Product Change Notification(PCN)

Power outlet, with snap-in, 6.3mm Fast-on Tabs

Change Notification # : PCN 20121217-A-KGB-S

Customer-No.		ASSMANN WSM-AG	A-KGB-S
Drawing-No.		ASS 0889E CO	rev04
Replace			SHEET

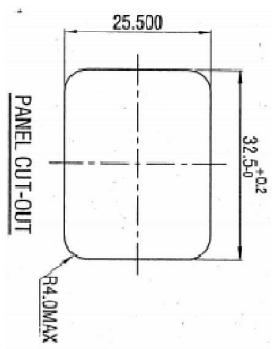
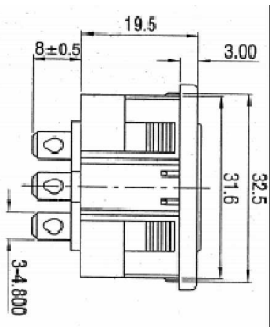
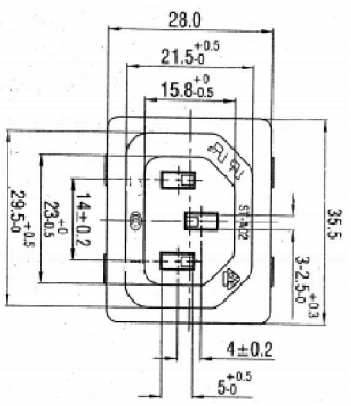
1. Amendment of the specification
2. Dimension overall height : New : 28.0 mm
3. Dimension length : New : 19.5mm
4. Dimension Panelcut-out : New : 25.5 x 32.5 mm R4.0max
5. Dimension Face width : New : 35.5 mm
6. Dimension backside width : New : 32.5 mm
7. Material Insulator : New : Nylon66
8. Catalogue 2010 shows different specification
9. Draw.-No. ASS 0889E C0rev04 substitutes ASS 0889E C0rev03

Key Characteristics of Change: some tiny dimensions

Reason for Change: Change of manufacturing location
